### **Application WD/2023/2516/MAJ**

1. We, the Steering Group of the Village Concerns Action Group, represent the views of over 250 supporters from our community and we object to Planning Application WD/2023/2516/MAJ. This letter is not just an objection. We also ask for clarification on some of the documents that you have posted on your website and we request an answer to those questions.

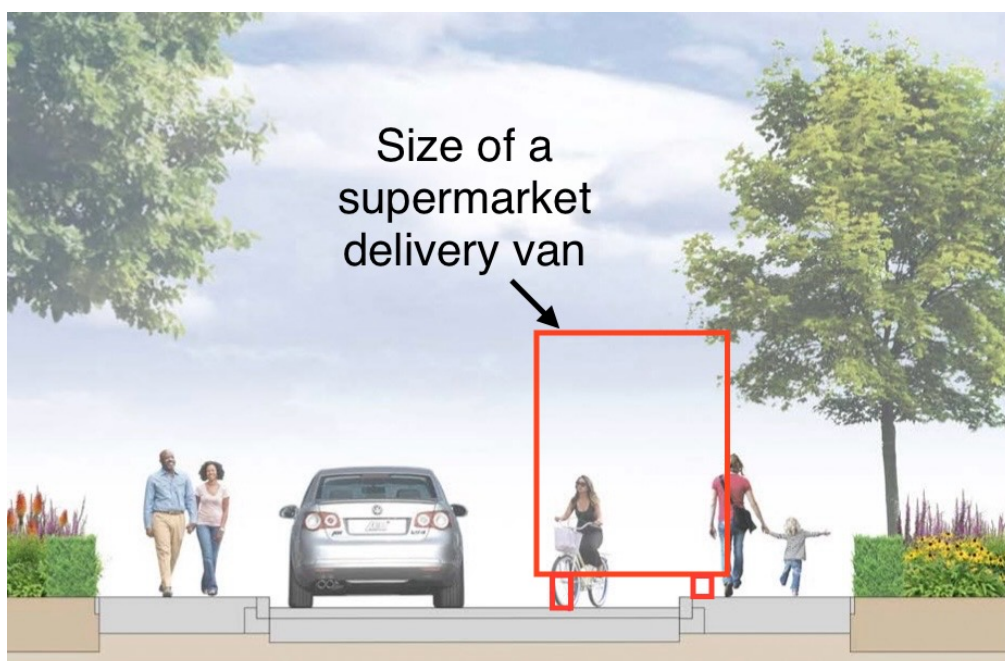
38. Paragraph 4.4 shows street scenes that bear little resemblance or relevance to the proposed designs. They attempt to paint an idyllic scene but the reality will be far different. An example of a more realistic view is shown below:
